Braidwood Station, Units 1 and 2  
Facility Operating License Nos. NPF-72 and NPF-77  
NRC Docket Nos. STN 50-456 and STN 50-457

Byron Station, Units 1 and 2  
Facility Operating License Nos. NPF-37 and NPF-66  
NRC Docket Nos. STN 50-454 and STN 50-455

Subject: Request for a License Amendment to Modify the Method of Controlling  
Unfavorable Exposure Time Related to an Anticipated Transient Without Scram  
Event for Byron and Braidwood Stations

#### DESCRIPTION AND SAFETY ANALYSIS FOR PROPOSED CHANGES

**Figure 1**  
**Hot Full Power MTC for Hypothetical High Reactivity Core**

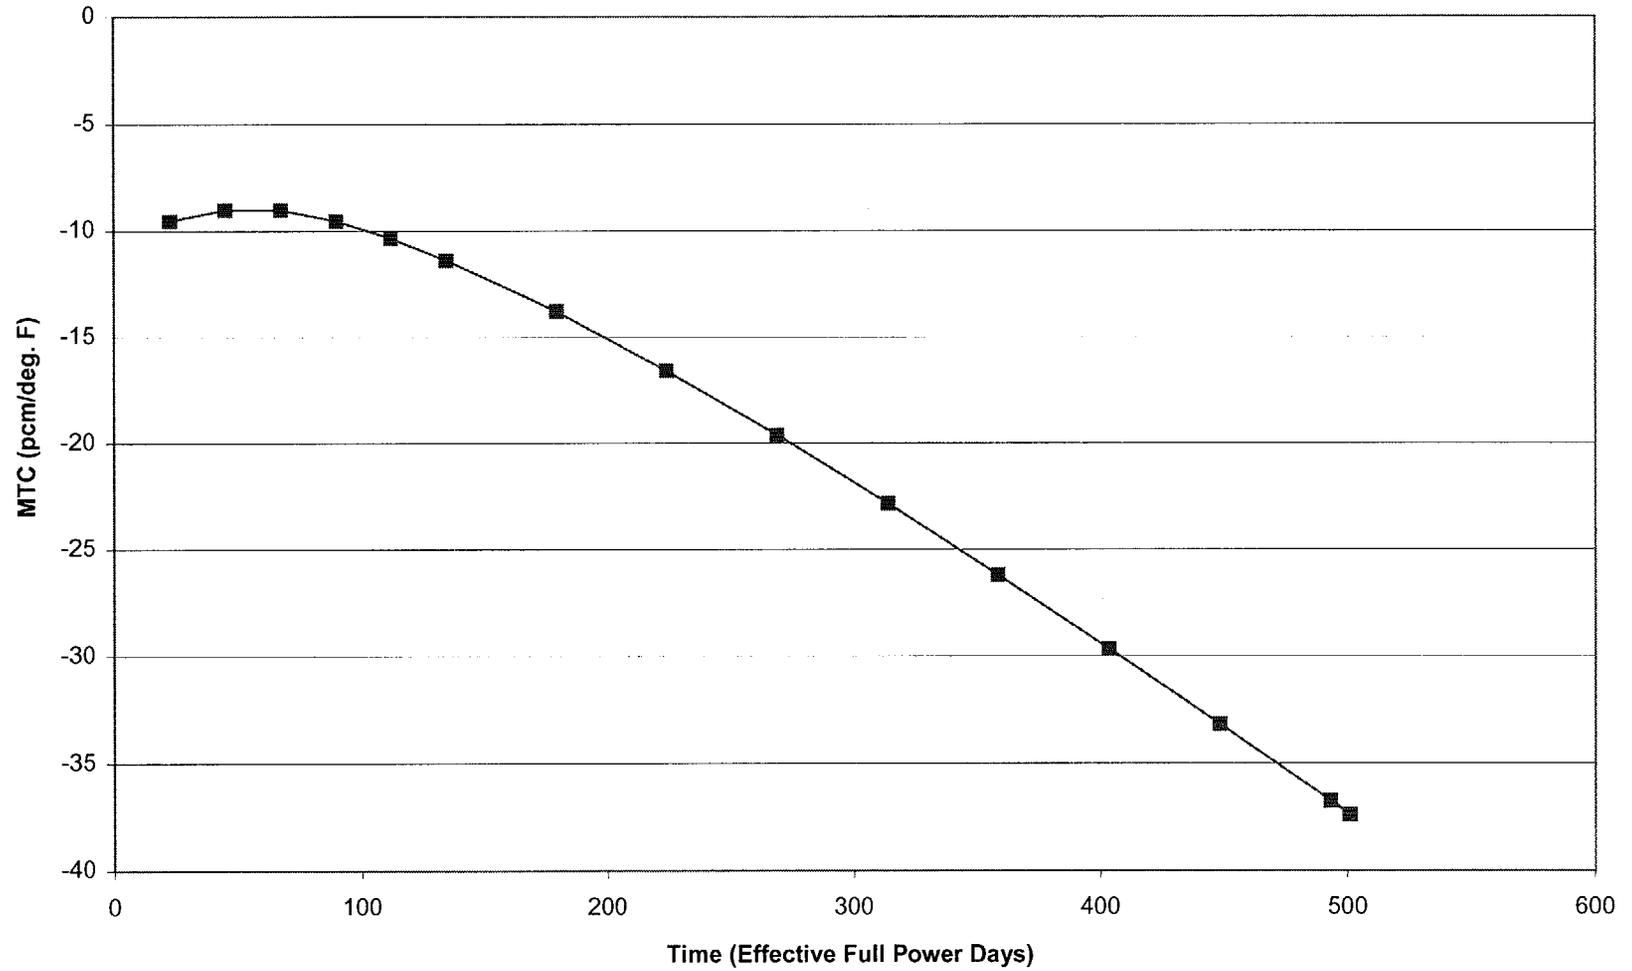
For informational purposes, Figure 1 shows the MTC profile as a function of burnup at HFP for this hypothetical high reactivity core.
